## **McGOWIN BUSINESS PARK SUBDIVISION,** **PHASE FOUR**

APPLICATION NUMBER 24 DATE August 5, 2004  
APPLICANT McGowan Business Park Subdivision, Phase Four  
REQUEST Subdivision

# MCGOWIN BUSINESS PARK SUBDIVISION, PHASE FOUR

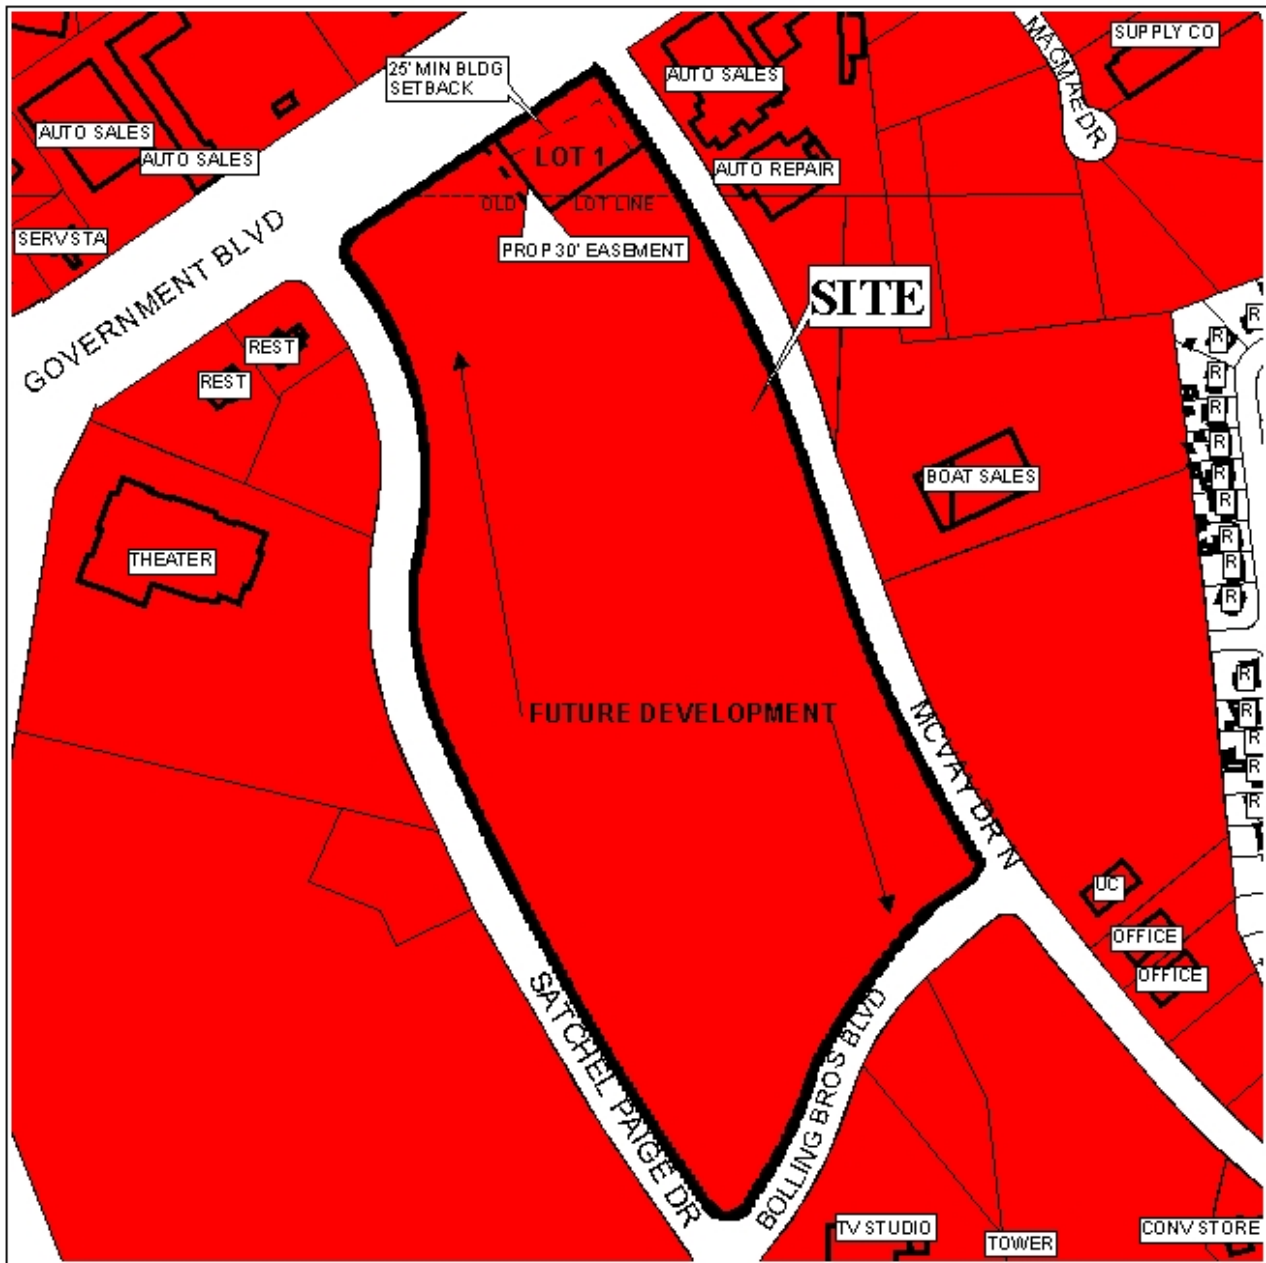
Engineering Comments: Significant stormwater drainage conveyance on area shown as “Future Development”. Please provide contours to define conveyance and dedicate appropriate easement. Must comply with all stormwater and flood control ordinances. Any work performed in the right-of-way will require a right-of-way permit.

Traffic Engineering Comments: Driveway numbers, size, location and design to be approved by Traffic Engineering and conform to AASHTO standards.

Furthermore, since the site is a corner lot, the dedication of a 25’ radius should be required. Access to McVay Drive should be limited to one curb cut, with size, location and design to be approved by the Traffic Engineering Department.

The plat meets the minimum requirements of the Subdivision Regulations and is recommended for Tentative Approval subject to the following conditions: 1) the placement of a note on the final plat stating that access to Government Boulevard is

limited to the 30' non-exclusive, perpetual easement for ingress and egress, with curb cut size, location and design to be approved by ALDOT and Traffic Engineering; 2) the placement of a note on the final plat stating that access to McVay Drive is limited to one curb cut, with size, location and design to be approved by the Traffic Engineering Department; 3) the dedication of a 25' radius at the corner of Government Boulevard and McVay Drive; and 4) dedication of appropriate drainage easements, as required by the City Engineering Department.
